Service Information

Category U	Repair Guidance	Ref. No. R024/06	Page 1 of 2
Coverage <input type="checkbox"/> Distributor only <input checked="" type="checkbox"/> Please inform your dealers		Date Issued March 31, 2006	
Please convey this information to your <input type="checkbox"/> Director <input checked="" type="checkbox"/> General Manager <input checked="" type="checkbox"/> Warranty Dept. <input checked="" type="checkbox"/> Parts Dept. <input checked="" type="checkbox"/> Training Dept. <input checked="" type="checkbox"/> Field Rep.		Date Revised	
Applicable Model Mazda6 (GG/GY) & Mazda5 (CR) with MZR-CD Engine	Applicable Countries or Specifications Europe

Subject: Unusual Noise from Drive Belt

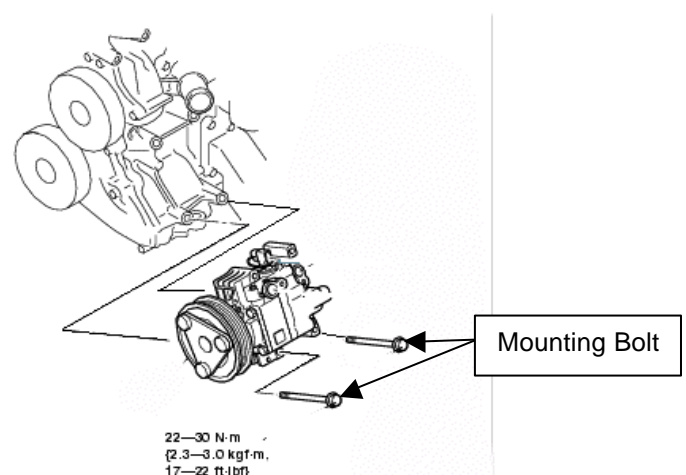
There is misalignment between the crank pulley and A/C compressor, which causes the unusual noise.

The bolt holes on the AC compressor has been made smaller in order to reduce the amount of misadjustment of AC compressor fitted location.

4. Loosen the 4 mounting bolts from AC compressor.
5. Move the AC compressor, and remove the 2 mounting bolts as indicated in the figure.
6. Install 2 service mounting bolts in the AC compressor.
7. Tighten the four mounting bolts to the specified tightening torque.
Tightening Torque: 22-30Nm

A/C compressor installation bolts (mounting bolts) with enlarged diameter will be available as service parts.

When you encounter a customer complaint on this concern, replace the two mounting bolts with service parts according to the following procedure.
